Headlamp Bracket Deformity

Vehicle Type: **911 Carrera (993), 911 Turbo (993) without Litronic headlight option**

Model Year: **911 Carrera, as of 1995 (S)
911 Turbo, as of 1996 (T)**

Former Arrangement

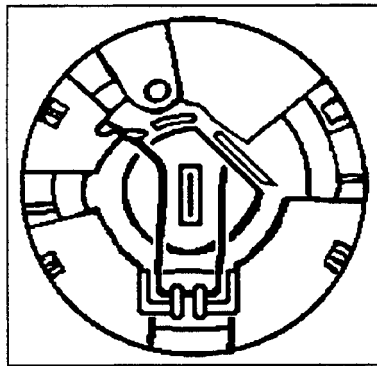
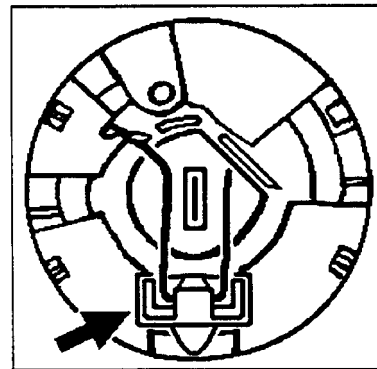
Concern: **Bracket for H1 headlamp (low beam) becoming deformed from heat.**

Information: The H1 lamp for low beam operation can become loose if the mounting area becomes deformed from heat. A new H1 lamp spring clip and retaining bracket are available, should this occur.

A repair kit, consisting of a stainless-steel spring clip and a modified retaining bracket should be installed, either as a preventative measure or a repair for deformity or warpage.

Work Procedure: Remove former H1 spring clip. Install new spring clip. Push the retaining bracket over the base area of the spring clip mounting. The retaining bracket must fully engage onto the lamp housing.
